**SUBDIVISION,
PLANNED UNIT DEVELOPMENT,
PLANNING APPROVAL &
ZONING AMENDMENT STAFF REPORT**

Date: March 15, 2018

<u>NAME</u>	Historic Restoration Society, Inc.
<u>SUBDIVISION NAME</u>	Lone Oak Subdivision, Revision and Addition to
<u>LOCATION</u>	901, 903, 907, & 911 Dauphin Street and 2, 6, 10 & 14 South Broad Street (Southwest corner of Dauphin Street and South Broad Street, extending to the North side of Conti Street)
<u>CITY COUNCIL DISTRICT</u>	District 2
<u>PRESENT ZONING</u>	B-1, Buffer-Business District, B-2, Neighborhood Business District, and B-4, General Business District
<u>PROPOSED ZONING</u>	Lot 1: B-2, Neighborhood Business District (<i>no change of zoning</i>); and Lot 2: B-4, General Business District
<u>REASON FOR REZONING</u>	The subdivision of land.
<u>AREA OF PROPERTY</u>	2 Lots / 4.5 ± Acres
<u>CONTEMPLATED USE</u>	<p>Subdivision approval to create 2 lots, Planned Unit Development Approval to allow multiple buildings on a single building site and shared access and parking between two building sites, Planning Approval to allow a float barn in a B-4, General Business District, and Rezoning from B-1, Buffer-Business District, and B-4, General Business District

SITE PLAN

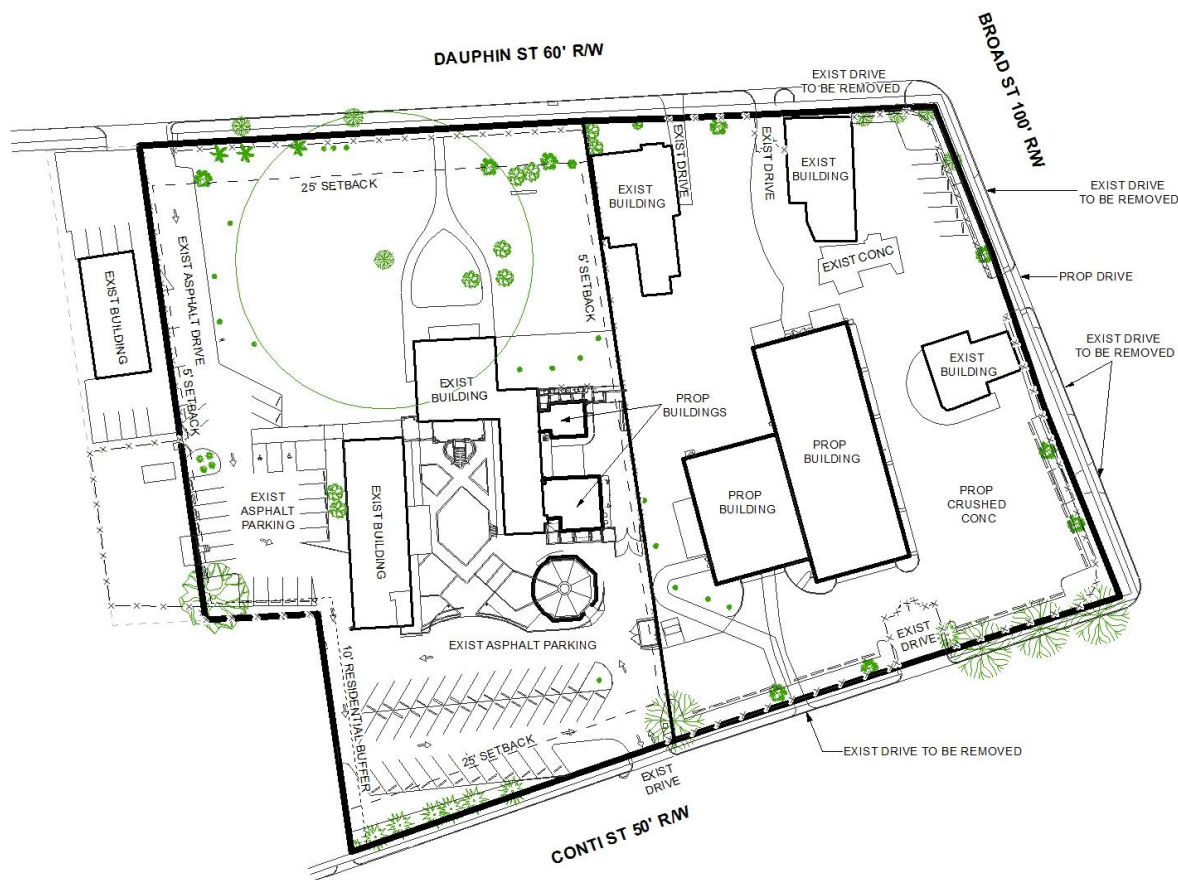
It appears that are proposed curb cuts shown exceed the number of curb cuts allowed as listed in PUD NOTE #1. Clarify the note and/or the proposed curb cuts.

minimum building setback for proposed Lot 2 (the proposed B-4 property) along Dauphin Street. The preliminary plat reflects this reduction, but the PUD and Planning Approval site plans do not.

Access management is a concern due to the site's location and frontage onto three streets. The site plan provided with the applications depicts that two gated curb-cuts to Dauphin Street will remain, and the driveway associated with the 907 Dauphin Street structure and that the existing 67-foot long curb-cut adjacent to 903 Dauphin Street will remain. One gated curb-cut to Broad Street is proposed to be retained, and two gated curb-cuts onto Conti Street are proposed to be retained. All other curb-cuts are labelled as to be removed and replaced with curb-and-gutter.

It should be noted that the site plan does not appear to be accurate. A site visit by staff observed that the construction office trailer has been relocated from behind 919 Dauphin Street to proposed Lot 2, and that a large portion of the fence separating 919 Dauphin Street from 911 Dauphin Street has been removed, allowing full pedestrian access between the two properties.

Staff also observed that the rear of the two residential properties at 918 and 920 Conti Street are being used for reserved parking spaces – that there are gates in the fence separating 911 Dauphin Street from the properties. Use of the residential properties for the 911 Dauphin Street site was of concern when the original event/meeting hall rezoning was proposed in 2014, and thus the properties were purposefully excluded from the original PUD, Zoning and Subdivision applications, yet it appears that they are being used anyway.

- 1) Revision of the site plan to include 919 Dauphin Street, and 918 and 920 Conti Street;

- 2) Submittal of labels and postage by March 26th so that appropriate notification of all property owners can occur for the PUD application, including the expanded PUD site; and
- 3) Revision of the site plan to reflect the minimum building setback lines shown on the preliminary plat, and to depict dedication along Broad Street

- 1) Revision of the site plan to include the proposed use of 907 Dauphin Street, and reflect any changes being made to the PUD site plan.
